**Pacific Gas and
Electric Company®**

PG&E Letter DCL-13-043

Diablo Canyon Units 1 and 2
Docket No. 50-275, OL-DPR-80
Docket No. 50-323, OL-DPR-82
Supplement to License Amendment Request 11-07, "Process Protection System Replacement"

Figure 3-2 PPS Replacement

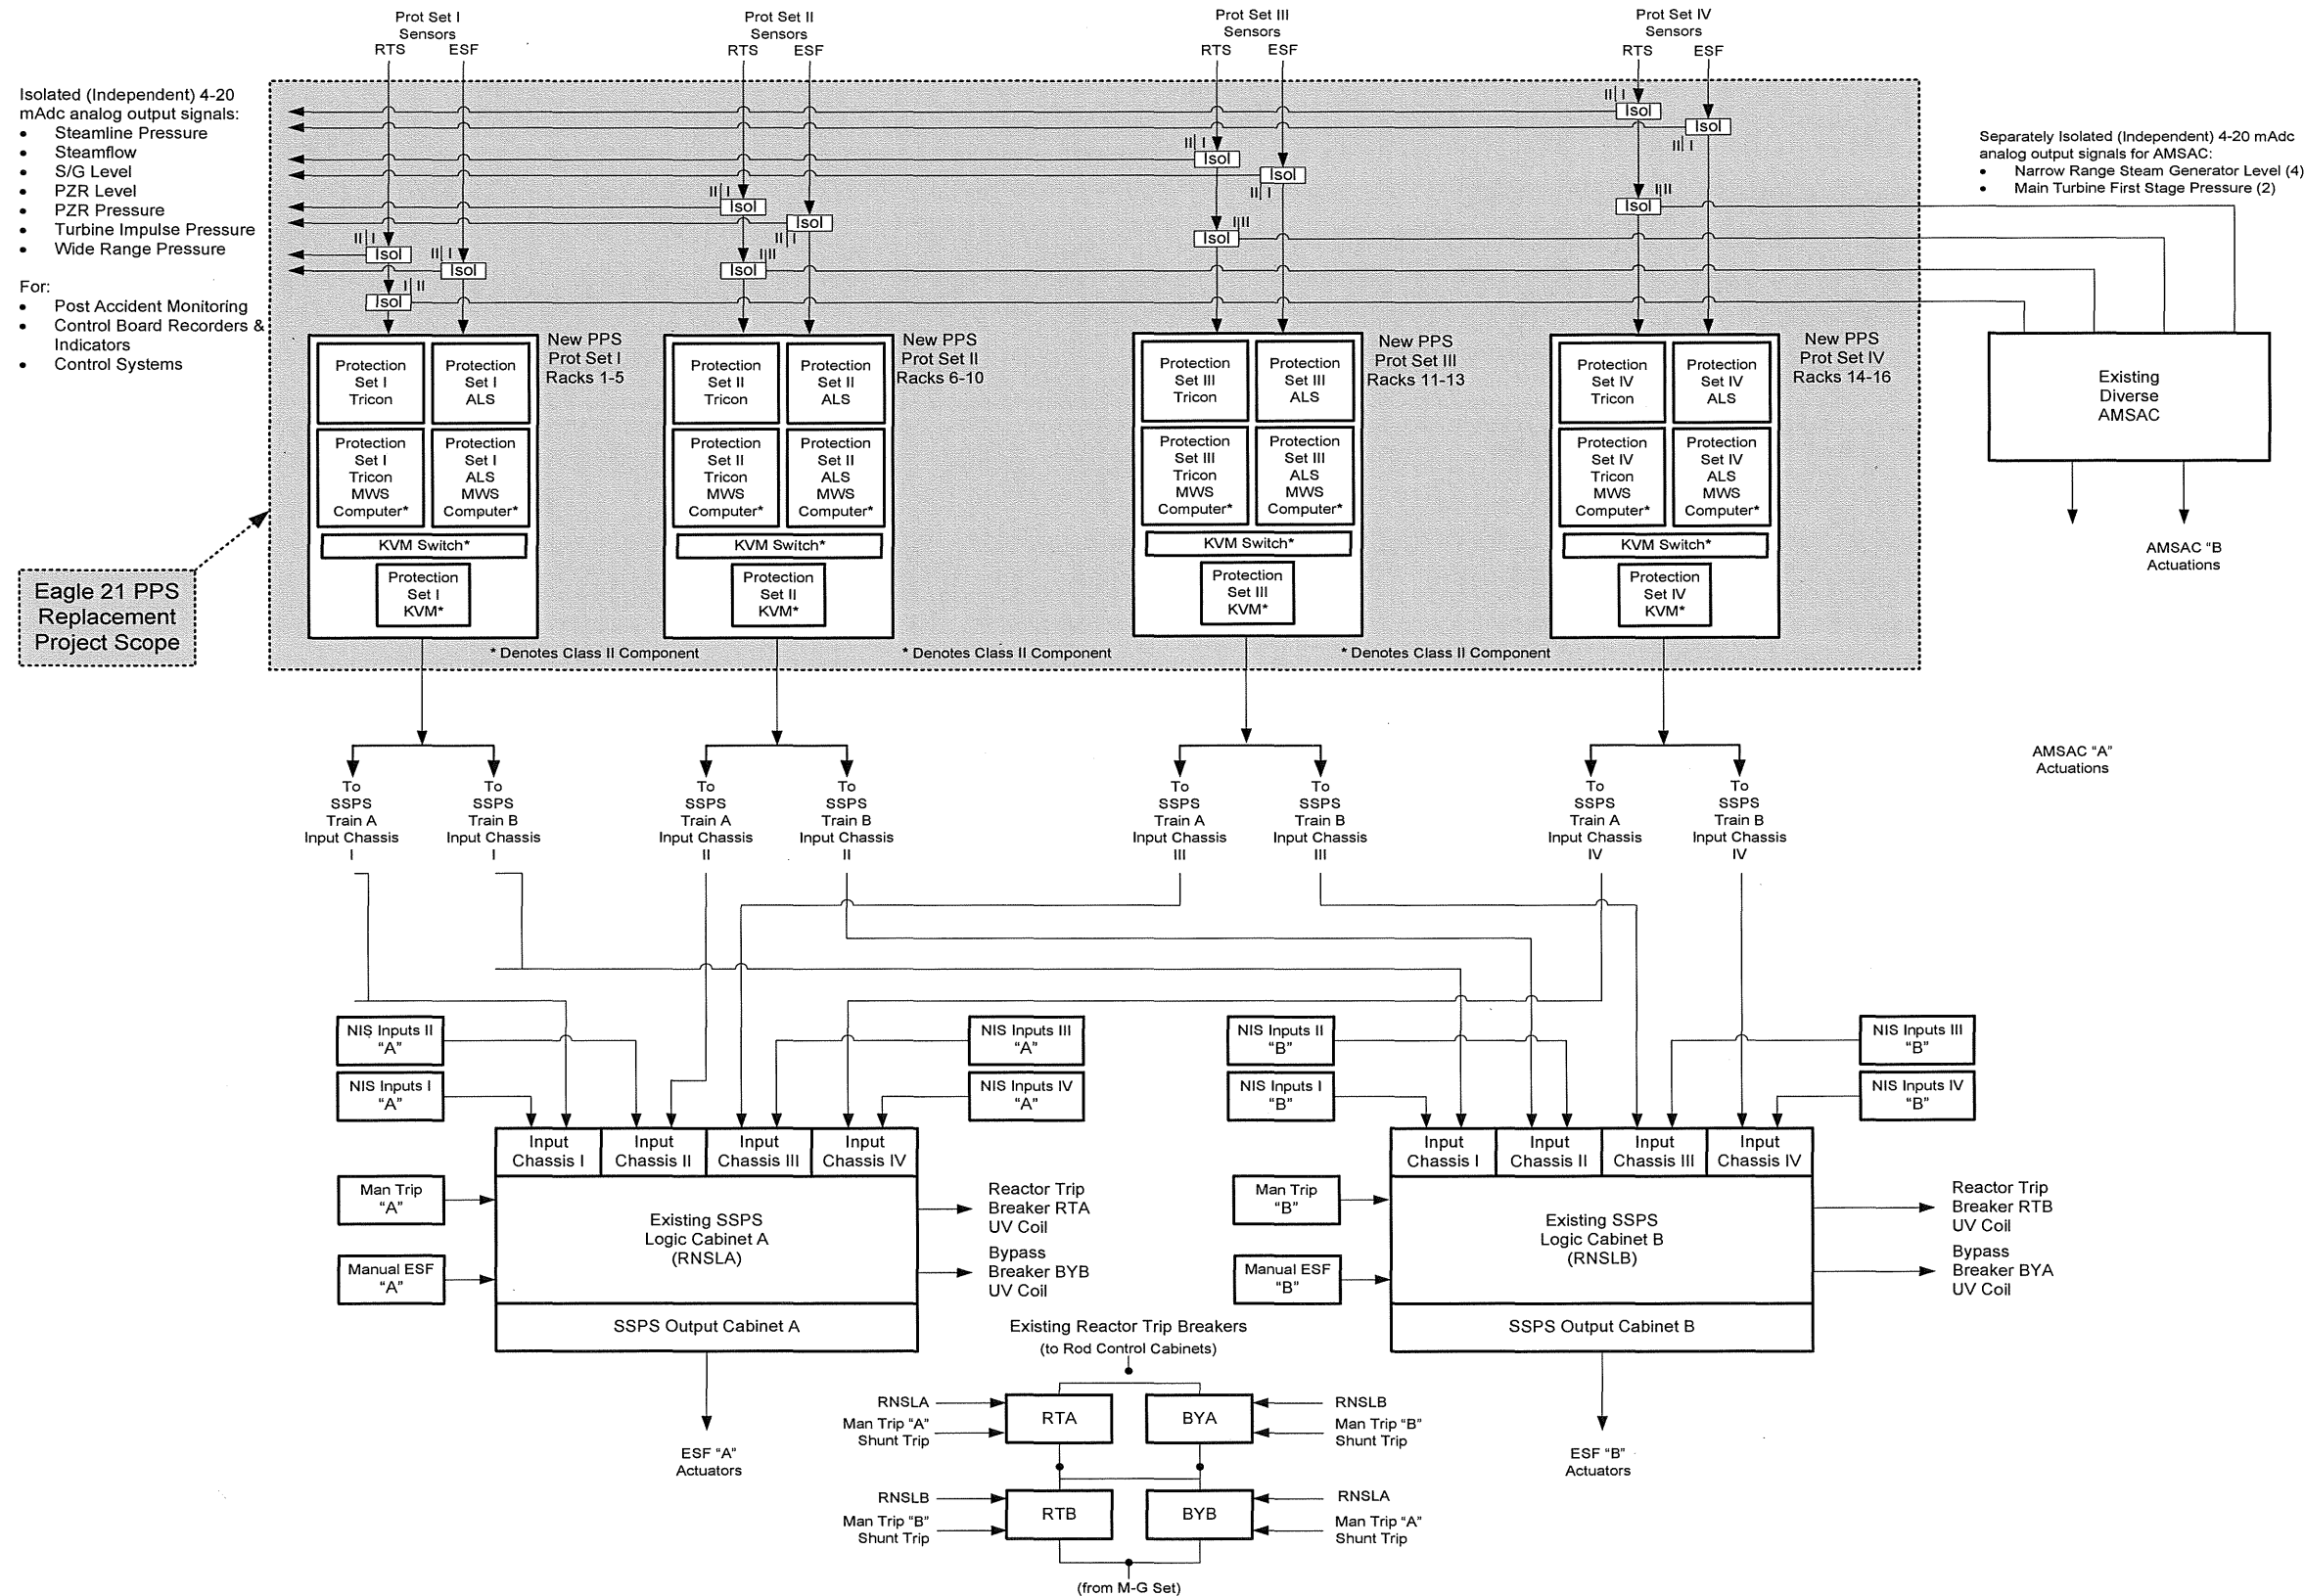
The proposed project replaces in its entirety the current Westinghouse Eagle 21 PPS with a new PPS that has improved reliability, diversity, diagnostic, and testing capabilities. Figure 3-2 contains an overview of the RTS and ESFAS including a simplified representation of the PPS replacement. The scope of the PPS replacement is illustrated in the shaded portion of Figure 3-2. Equipment in the unshaded portion of Figure 3-2 is not being replaced or modified as part of the PPS Replacement Project. The existing Eagle 21 PPS four redundant Protection Sets, as shown in Figure 3-1, will

Figure 3-3 PPS Replacement Communications

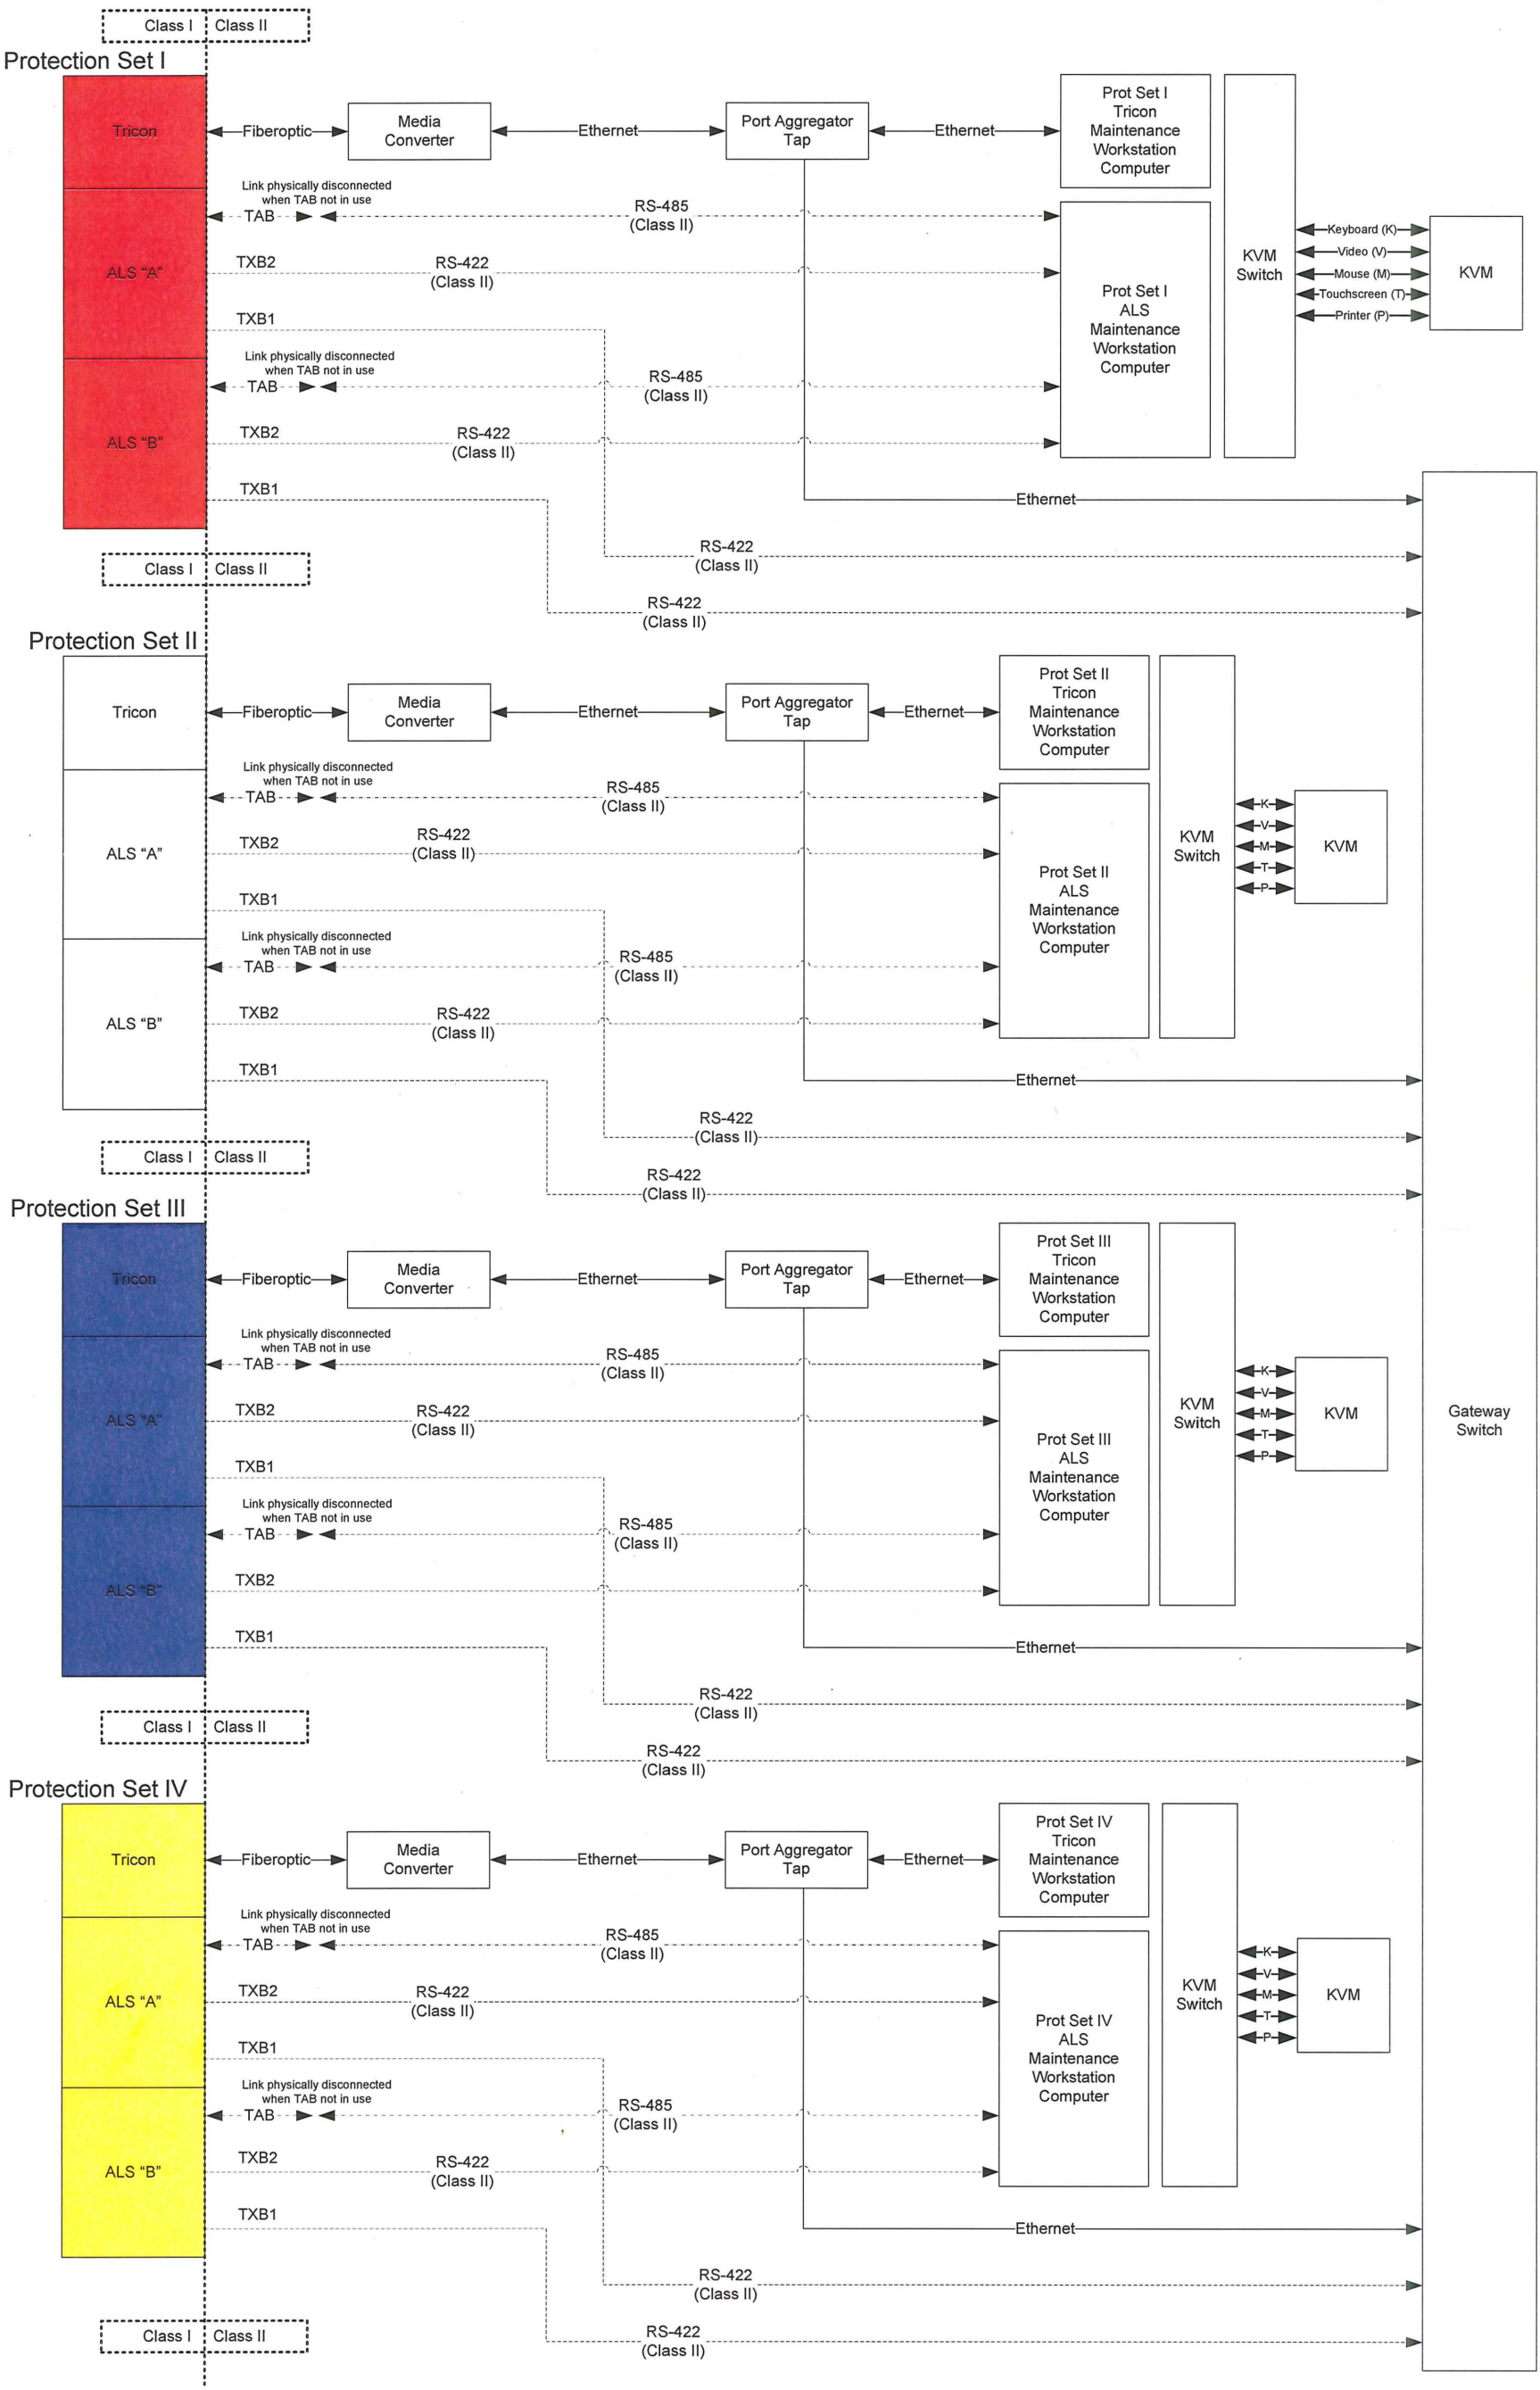
Figure 3-3 provides a simplified representation of the communications architecture for a single Protection Set. The Tricon, ALS, Tricon subsystem MWS, and ALS subsystem MWS communications are summarized below.

There are no communication paths between redundant safety divisions in the ALS portion of the PPS replacement as shown in Figure 3-3. The two Electronic Industries Alliance EIA-422 standard ALS communication channels (TxB1 and TxB2) from the ALS-102 in each ALS chassis to the PDN Gateway Switch and the ALS MWS, respectively, are isolated, serial, and one-way. The communications channels do not receive any data, handshaking, or instructions from the PDN Gateway Computer connected to the PDN Gateway Switch. Handshaking is an automated process of negotiation that dynamically sets parameters of a communications channel established between two entities before normal communication over the channel begins. The ALS processes reactor coolant system (RCS) temperature signals and transmits the conditioned and scaled data to the Tricon via analog 4-20 milliampere (mA) signals.

Separate and independent non-safety-related MWSs shown in Figure 3-2 and Figure 3-3 are provided for the Tricon and ALS subsystems, respectively, for each Protection Set to allow PPS information processing and display, and to facilitate maintenance. The two MWSs in each Protection Set share common peripheral devices such as the keyboard, video display, mouse, touchscreen interface, and printer through a Keyboard-Video-Mouse (KVM) switch. The Tricon MWS is dedicated to the Tricon PPS subsystem in the respective set; the ALS MWS is dedicated to the ALS PPS subsystem in that set. The two MWSs cannot communicate with each other nor can they communicate with the MWSs in redundant protection sets.
